Town of Little Elm

TOWN COUNCIL

REGULAR MEETING

PUBLIC HEARING/ Oak Grove Planned Development (PD-23-10136)

Proposal

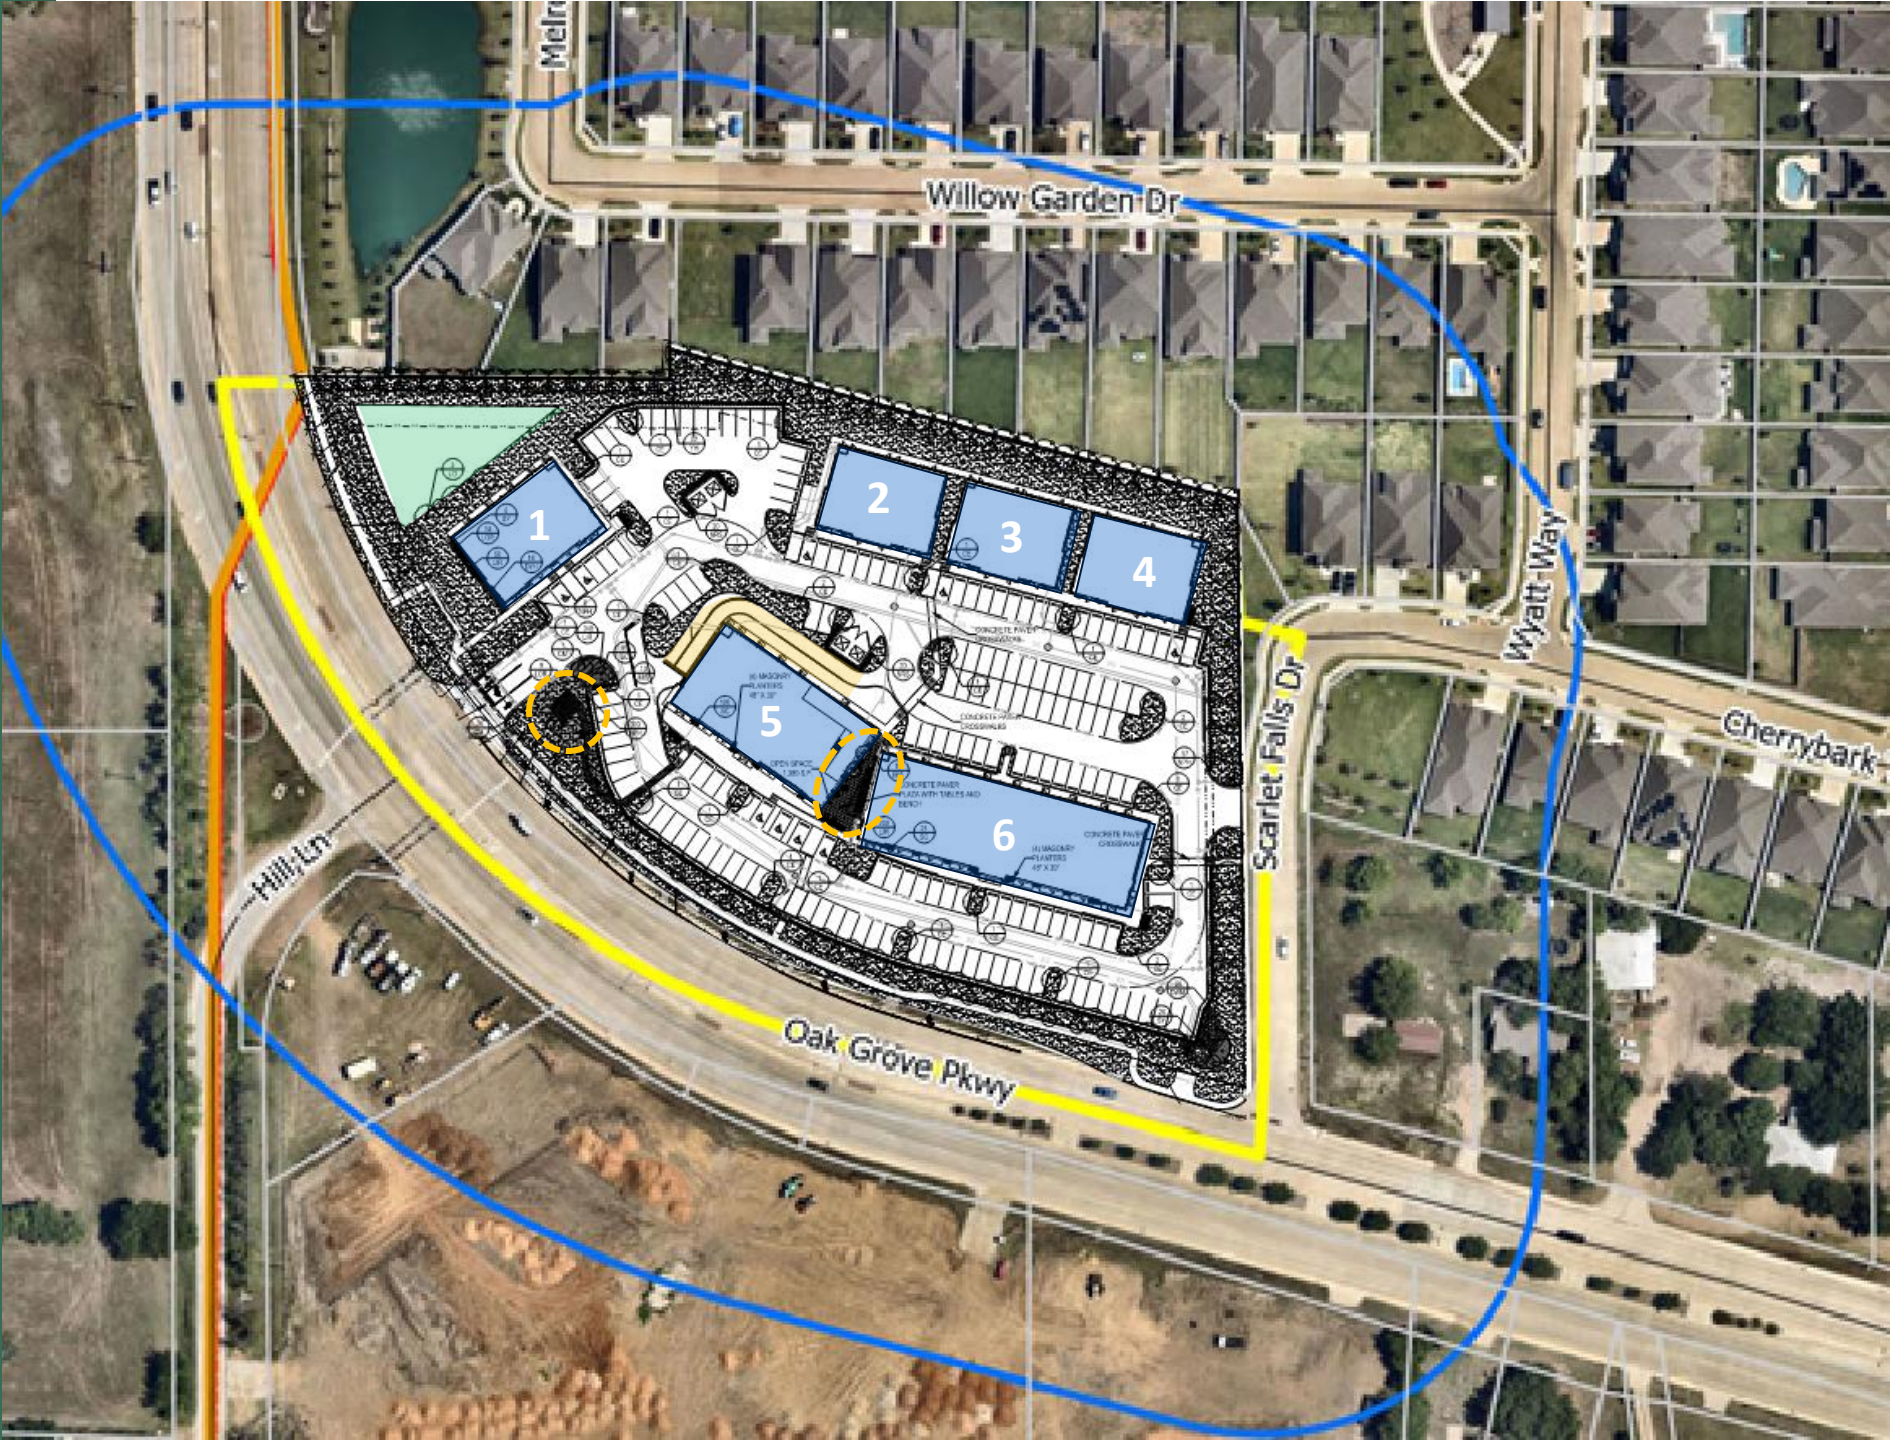
At their regular meeting on September 21, 2023, Planning and Zoning Commission had concerns over the standalone drive-thru due to proximity to adjacent residents and potential nuisances.

- First Submittal contained 2 lots. Lot 1 on the north portion, housed a standalone drive-thru, and Lot 2 housed the current commercial retail and office buildings, with one end-cap drive-thru, as shown.
- Several residents were in support of the proposed development but spoke about concerns of increased traffic, screening wall, and operation hours, noise and odor nuisances specific to the standalone drive-thru.

- Applicant had re-oriented the standalone drive-thru further from the adjacent neighborhood.
- Despite the revised layout, while the Commissioners were generally supportive of the proposed commercial development but did not feel comfortable allowing a drive-thru on the northern portion of the site.
- Several of the same residents attended the public hearing and voiced the same concerns over the drive-thru proximity.

- ***Previously proposed standalone drive-thru was replaced with a commercial retail building, as presented.***

Standards: Building Design Building 1

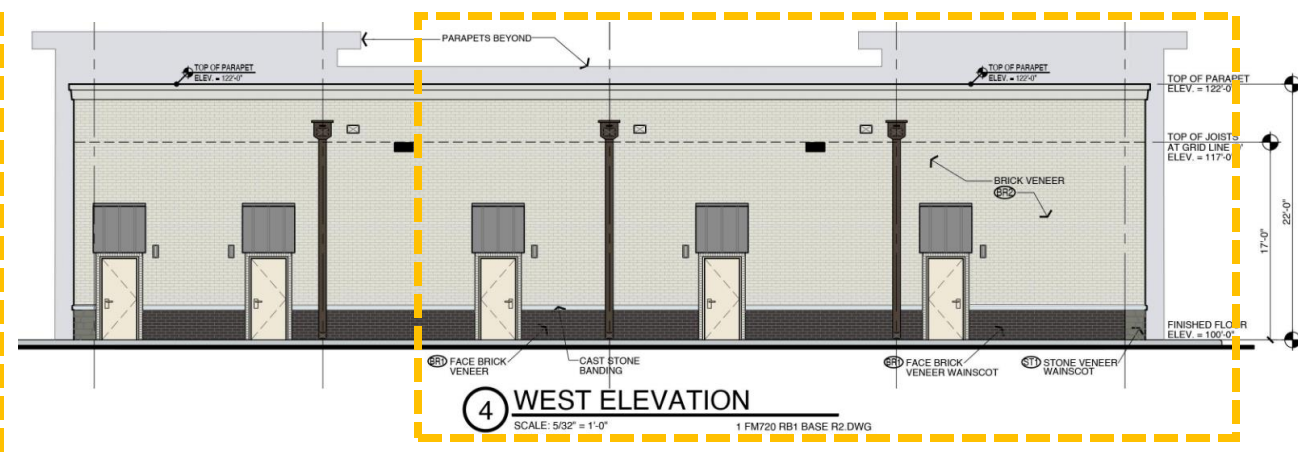
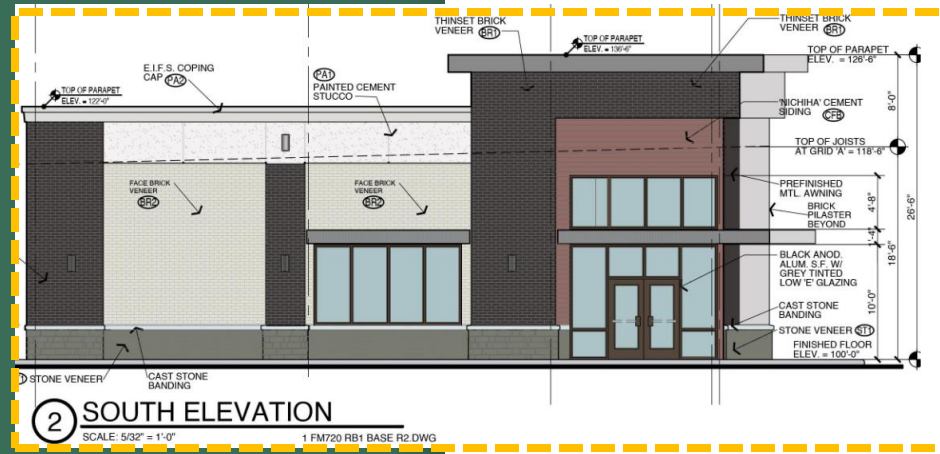
Building 1 Facades most visible from the street need to be enhanced to create a perception of an active storefront.

- Facade materials calculations tables for Building 1 need to be revised to show correct square footages and percentages.
- Building 1's orientation on the site creates three primary facades, East, South, and West, which are clearly visible from Oak Grove Parkway.
 - Staff believes that these facades should be redesigned to enhance the design and increase the glazing in order to create the perception of an active storefront.
- When the site plan was revised, the detention pond was relocated to the northernmost portion of the site, which eliminated previously shown pedestrian walkway. Typically, the Town requires detention/retention ponds to provide certain landscape enhancements and pedestrian amenities in an effort to utilize these areas as an added green space.
 - Staff believes that there is opportunity to provide such amenities here.

1. Facade materials calculations tables for Building 1 need to be revised to show correct square footages and percentages.
2. Building 1's South and West facades should be redesigned to enhance the design and increase the glazing in order to create the perception of an active storefront.
3. Detention/Retention areas along a right-of-way shall be amenitized with improvements such as, but not limited to, a bench, shaded seating structure, pavilion, and enhanced landscaping. A paved walking path must be provided surrounding the area and connecting to existing sidewalks along the right-of-way and pedestrian paths within the development.
